**SOLICITATION AMENDMENT
MODIFICATION DE L'INVITATION**

Title - Sujet DND Workplace Furniture	
Solicitation No. - N° de l'invitation EB129-211701/B	Amendment No. - N° modif. 001
Client Reference No. - N° de référence du client EB129-211701	Date 2021-02-12
GETS Reference No. - N° de référence de SEAG PW-\$XAQ-027-7561	
File No. - N° de dossier XAQ-0-43122 (027)	CCC No./N° CCC - FMS No./N° VME
Solicitation Closes - L'invitation prend fin at - à 02:00 PM Newfoundland Standard Time NST on - le 2021-03-02 Heure Normale de Terre-Neuve HNT	
F.O.B. - F.A.B. Plant-Usine: <input type="checkbox"/> Destination: <input checked="" type="checkbox"/> Other-Autre: <input type="checkbox"/>	
Address Enquiries to: - Adresser toutes questions à: Walsh, Heather	Buyer Id - Id de l'acheteur xaq027
Telephone No. - N° de téléphone (709) 631-1853 ()	FAX No. - N° de FAX (709) 772-4603
Destination - of Goods, Services, and Construction: Destination - des biens, services et construction: Department of National Defence 84-86 Elizabeth Avenue, Regatta Plaza II, St. John's, NL A1B2E6

CONTRACT AMENDMENT 001

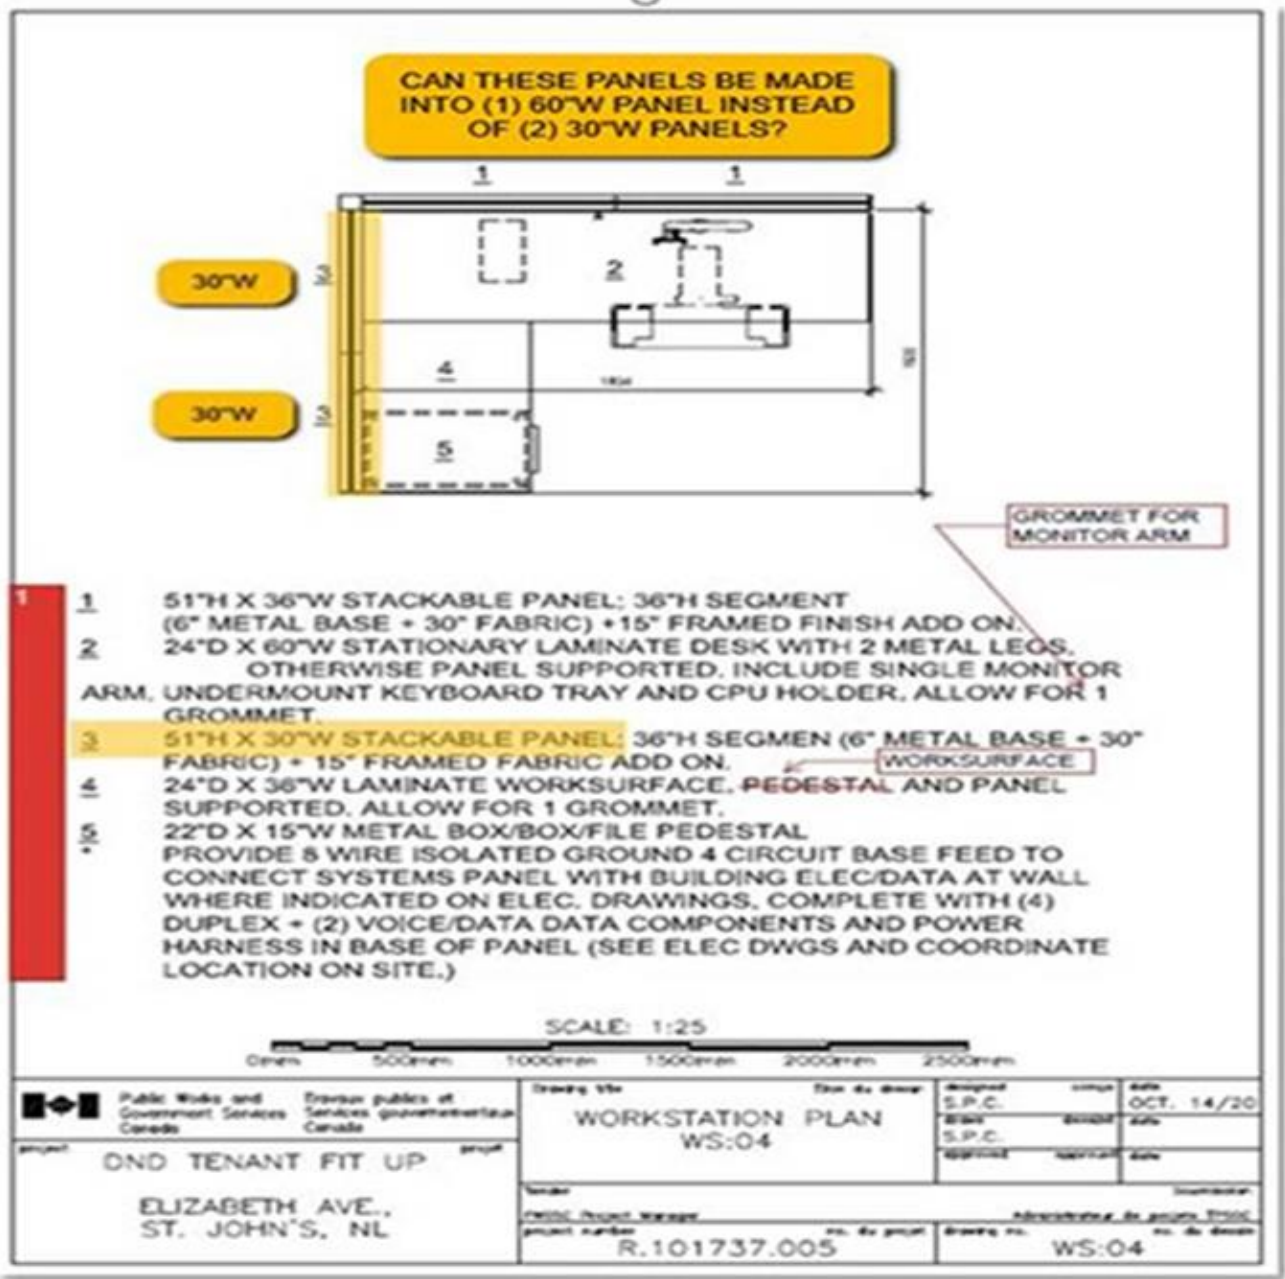
Q12. I see the data locations in each station on the electrical plan, but not duplex/triplex locations. You want 4 duplexes (8 plugs total) per station, would 3 triplexes be acceptable (9 plugs total).

Powered panels are not indicated on the plan (floor plan, or typical details), am I to assume we can power them at our discretion?

- PSPC Response: The issue for construction electrical drawing is attached for reference. 3 triplexes is be acceptable.
- Réponse du SPAC : La question pour les travaux de construction dessin électrique est jointe pour renvoi 3 triplex est acceptable.
